## ■ SEAT

### 1. Front Seat

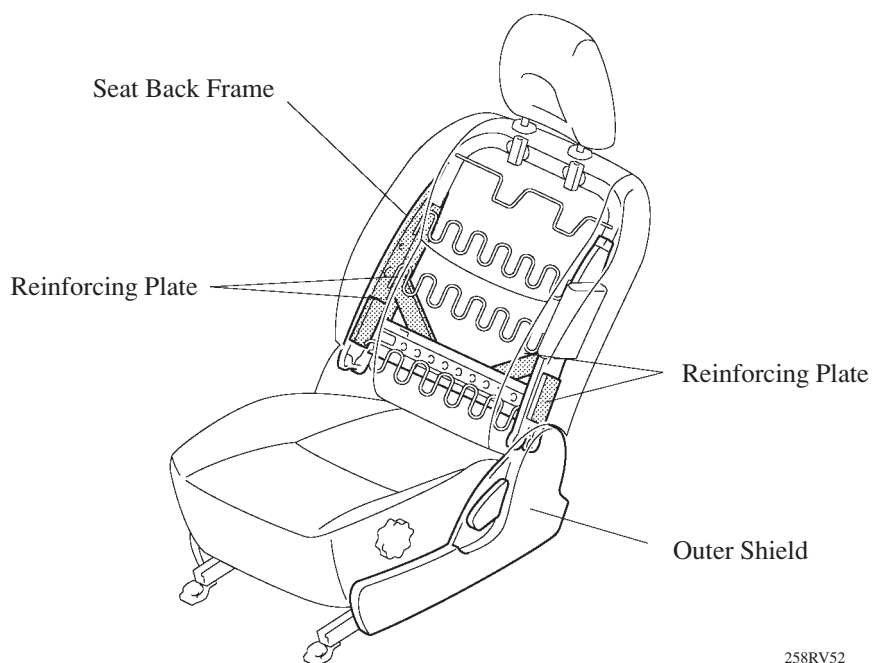
To realize the excellent rigidity of the seat frame of the models equipped with seat side airbags and curtain-shield airbags, the construction of the seat frames and headrests has been changed. Accordingly, the shape of the outer shield has been changed.
